STAFF REPORT: SEPTEMBER 11, 2024 MEETING PREPARED BY: A. DYE

APPLICATION NUMBER: HDC2024-00436

ADDRESS: 1321 LABROSSE

SCOPE: DEMOLISH GARAGE, ERECT GARAGE (WORK COMPLETED WITHOUT APPROVAL)

Garage erected without HDC approval. Aerial images, April 2022. EagleView.

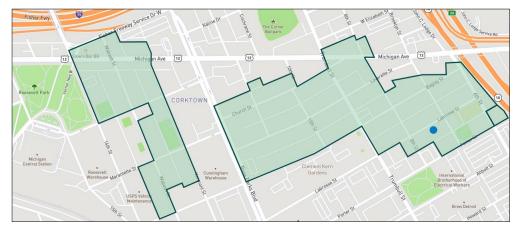
- It is staff's opinion, the demolished garage was not historically significant, and its collapsed walls and roof offered confirmation that the structure was deteriorated beyond repair. The erected structure has a compatible massing and design for this property and alley location.

- o The existing garage sits on the former garage's concrete foundation, which fills the width of the lot.
 - o The roof has the same forward-facing gable design but was erected with a higher pitch.

- The centrally placed door on the yard-facing wall is similar, but the wall doesn't have any window openings. The applicant is proposing to install one centrally placed window above the door within the gable area.

- However, the use of vinyl siding and the proposal to install a vinyl window is not compatible with the historic
 district
 - Staff notes that the new vinyl siding installation is already failing, consistent with the low quality of those materials.

- The vinyl siding will be replaced with wood or cementitious lap siding. If a cementitious product is used, it must have a smooth finish. The wall and trim paint colors will be submitted to staff for review.
- The proposed window will be an aluminum-clad wood product. A cut sheet confirming operation, material, finish and color will be submitted to staff for review.
- The drawings submitted for permit will be revised to show the placement of the proposed window, list the approved siding product and the width of its exposure, and exterior color palette for the siding, trim, and window. The window cut sheet will also be included in the applicant's documents.
